Our Ref: 110965.02 - Westlink Mod 5 - Response to Agency Comments on Stormwater.docx

Subject: Westlink Stage 1, MOD 5 --Response to Agency Comments on Stormwater

This letter has been prepared in response to Agency comments raised recently relating to the Westlink Stage 1 MOD 5 – External Road Upgrades

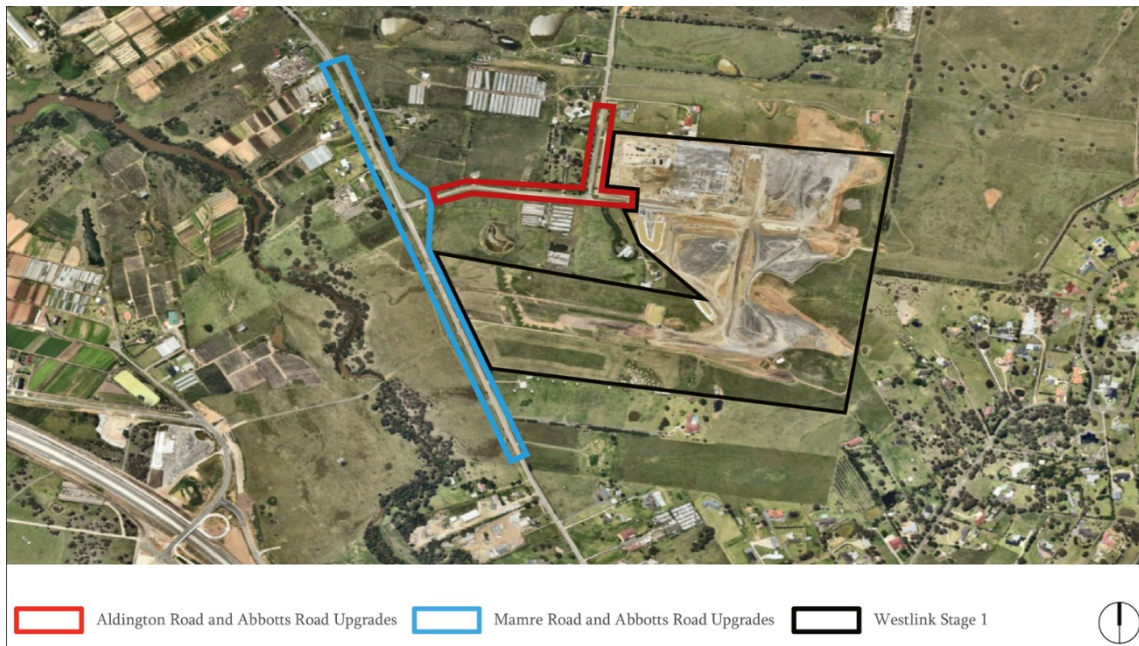
In considering this approach it is important to consider the relative increases in impervious areas associated with the upgrade of the portions of Mamre Road, Abbots Road and Aldington Road affected by MOD 5 (as highlighted in the extracted Figure 6 from the Mod application report below).

The relative proportions and scale of the additional impervious areas created have been derived from an assessment of the expected Road corridor formations as defined in the Mamre Road DCP and based on the current designs for the upgrade works completed by AT&L. The estimates are presented in Tables 1 and 2.

As summarised in Table 2 the increase only relates to a very small (0.30%) proportion of the overall impervious area within the catchment. As acknowledged by the agencies, this remaining catchment will be serviced by the SW stormwater infrastructure when it is commissioned in a few years.

Given the scale and speed of the development across MRP, it is considered that the relative impacts on flows and water quality in Wianamatta South Creek arising from these proportionately small increases in impervious areas are quite likely to be negligible.
